# RENESAS TECHNICAL UPDATE

Product Category	MPU&MCU		Document No.	TN-H8*-276A/EA	Rev.	1.0
Title	H8/3802, H8/38004, H8/38104 Group Hardware Manual, H8/38024, H8/38024S, H8/38024F-ZTAT, H8/38124 Group Hardware manual, H8/38086 Group , H8/38076 Group Hardware manual Error correction		Information Category	Correction or Supplement of Document		
Applicable Product	Stated below	Lot No.	Reference Document	Stated below		
		All

We will report correcting because there was clerical error for the function clarification of Asynchronous Event Counter (AEC) of H8/3802, H8/38004, H8/38104 Group Hardware manual, H8/38024, H8/38024S, H8/38024F-ZTAT H8/38124 Group Hardware manual, H8/38086 Group , H8/38076 Group Hardware manual.  
Please refer to the following for the detail.

Section9 Timers  
9.4 Asynchronous Event Counter (AEC)  
9.4.4 Operation Figure9.10 Event Counter Operation Waveform

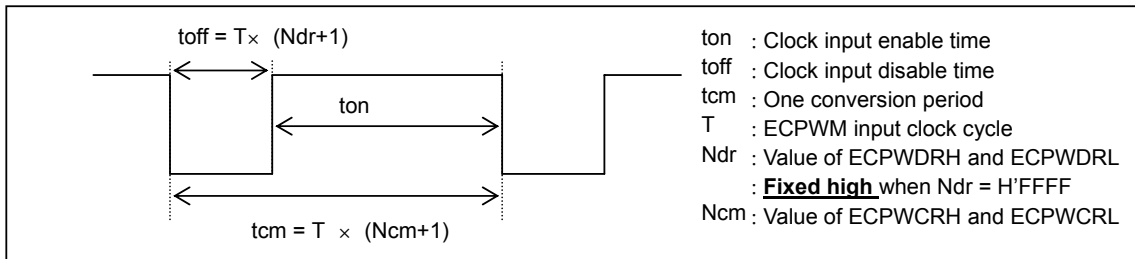
Content of error correction

(Before the amendment)

(After the amendment)
